Ant & Matching

DATE E. S. PARK
 CHKD 2006/07/28
 APPRD S. M. Park
 REF S. M. Lee
 MAN
 ISSUE :
 CONTENT : Rev. 1. 1

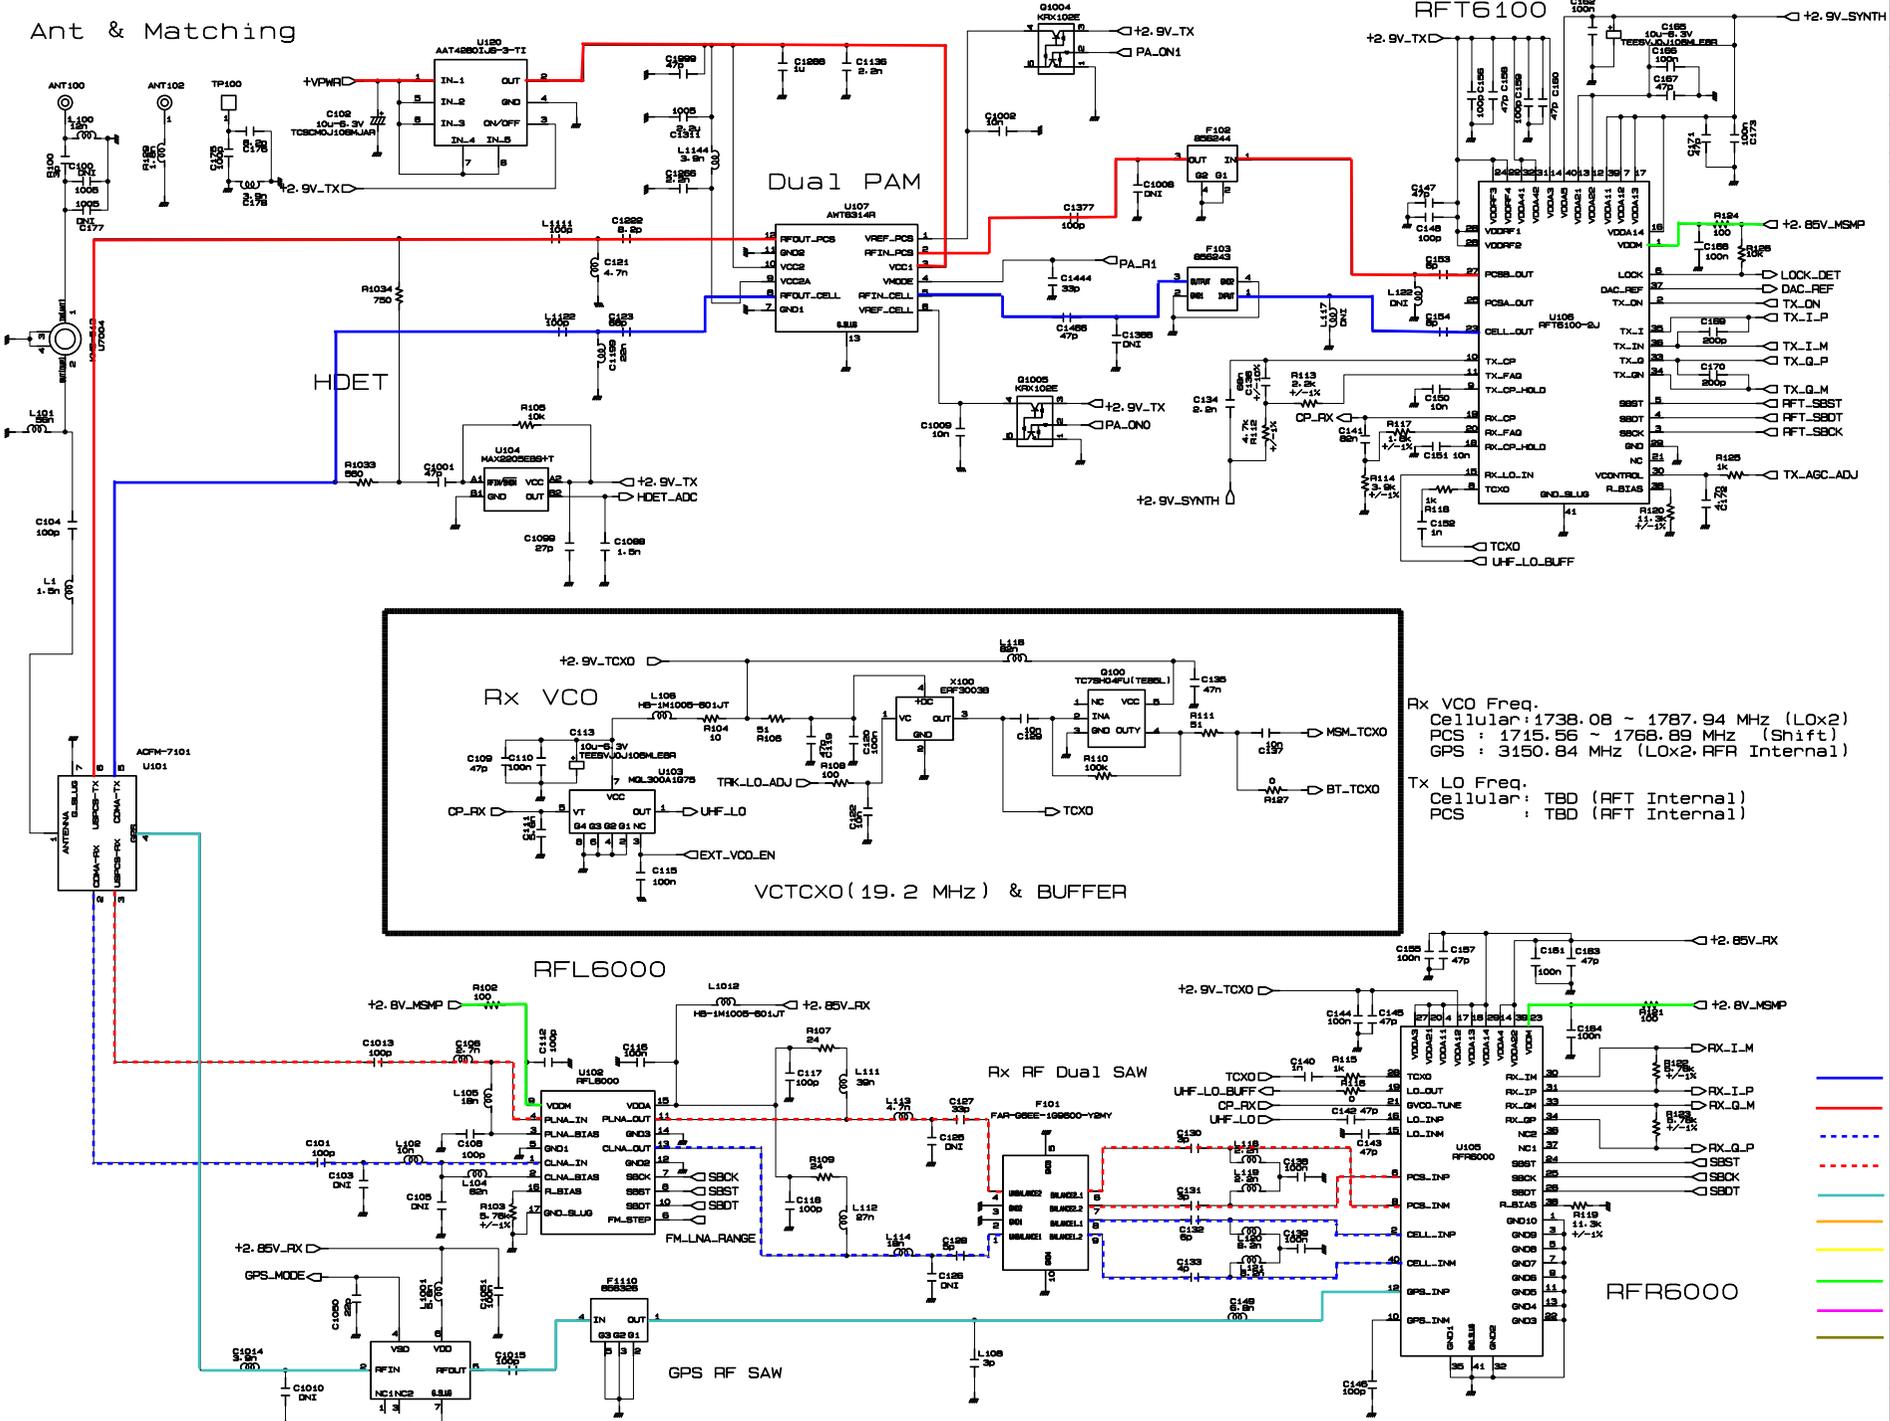
Rev. C
 Delete : GPS Filter
 L1022-1033-1044-1055

ADD : R1244

Change : Ref SW
 C1311 1005->1608

C1199 47n->20nI
 R1033 680->750

R1034 680->750

Delete : R1244

ADD : C1999 47pF

Change:G1004-G1005

KRX102F->KRX102E

C1311 1608->1005

C124 0.5p->2.7n

L1111 2.2n->100p

C1222 66p->6.8p

C1199 DNI->22nH

L1222 3.9nH->100pF

C106 82pF->2.7nH

L114 100pF->18nH

C128 10nH->25pF

C133 6p->4pF

C130-131 3p->2.4pF

L120-121 10n->8.2nH

C1014 1nH->4.7nH

L108 DNI->3pF

C121 2.7nH->3.3nH

ADD : C177 47pF Ant Match

C177 56nF HIndge Match

C176 8.2pF HIndge Match

C178 3.9nF

< MSM6050 IBM >

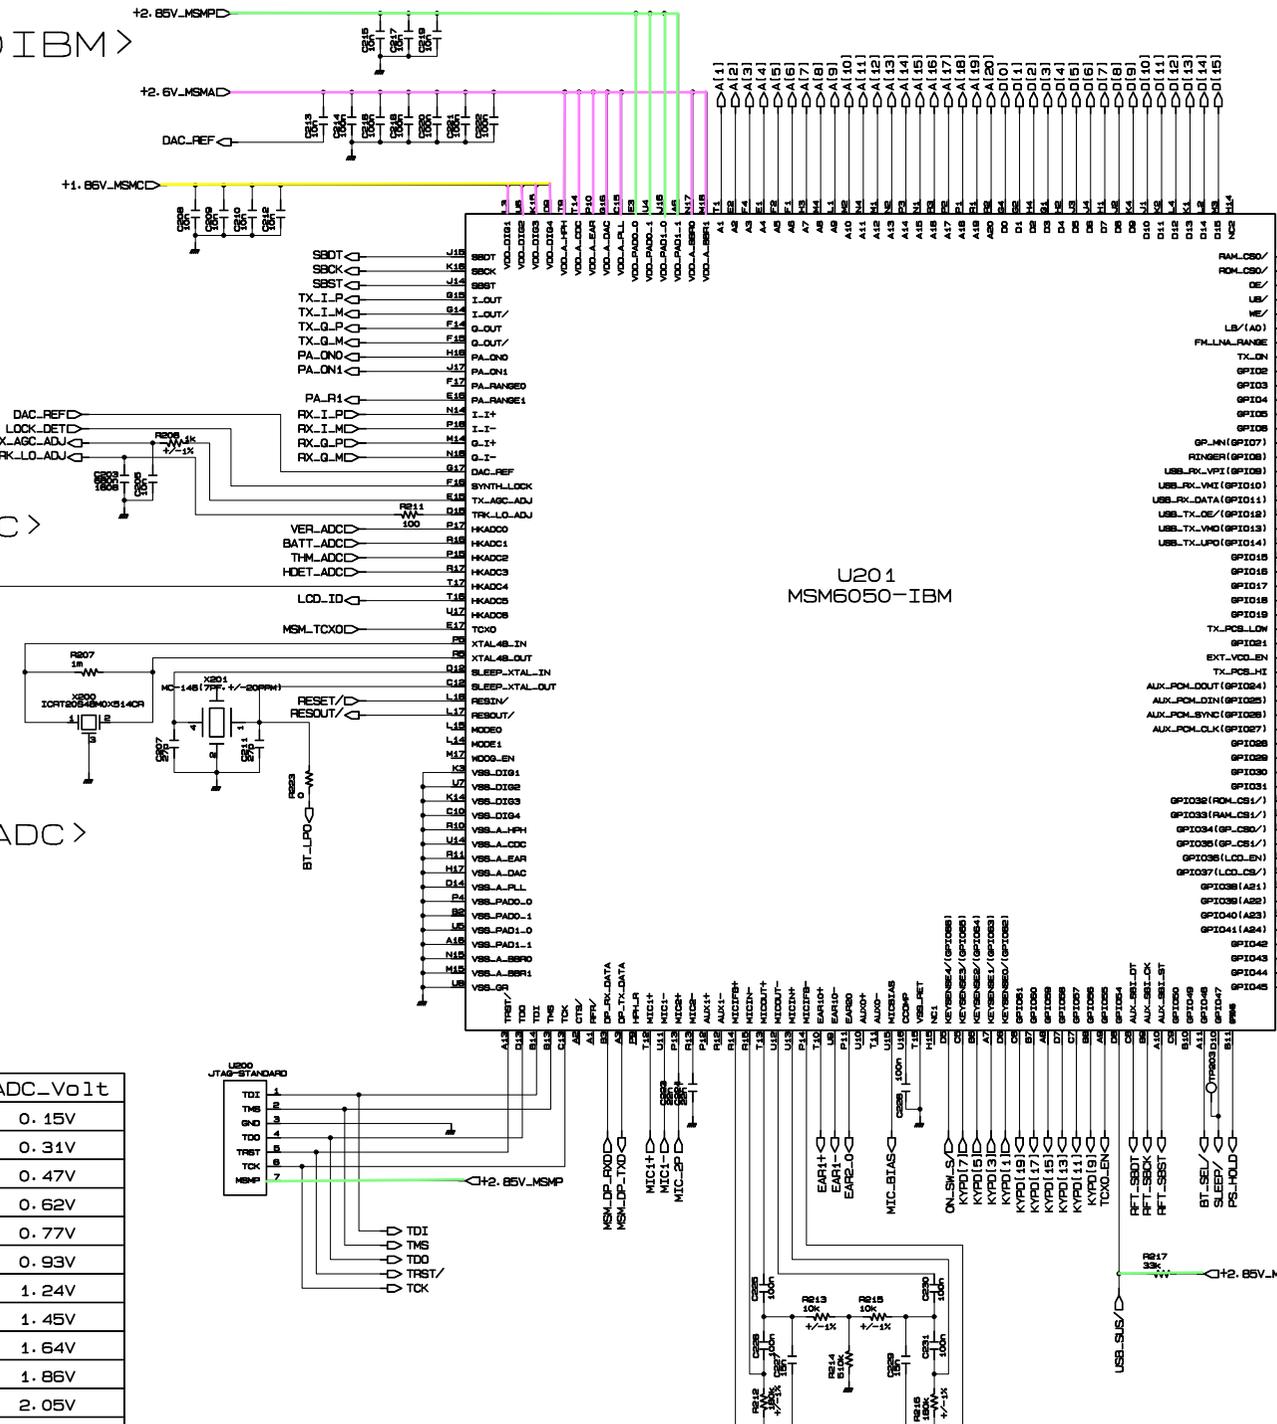
- Rev. B
 USB_SUS / Res. (R216)
 Pullup Res. (R216)
- Rev. C
 BATT_THM ADC added
 GP10 BT_WAKE added
- Rev. D
 BATT_THM power change :
 +2.85V_Rx -> +2.6V_MSMA
- Rev. E
 R221, R222 : 10k -> 4.7k
 Rev. 1. 0

- Rev. 1. 1
 R221, R222 : 10k -> 4.7k
 PCB Revision Voltage
 +2.85V_Rx -> +2.85V_MSMP

<MAIN KEY>

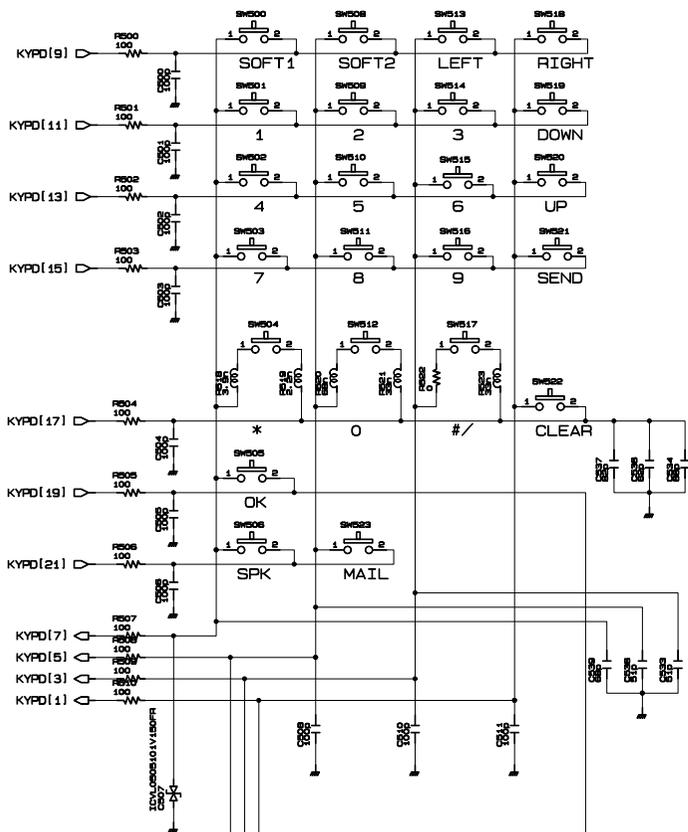
Rev. D
R514: 515 → 470ohm → 51

Rev. E
Mail Key defined

Rev. H
R511 : 1k0hm → 68k0hm

Rev. 1. 0
R528- R535 deleted
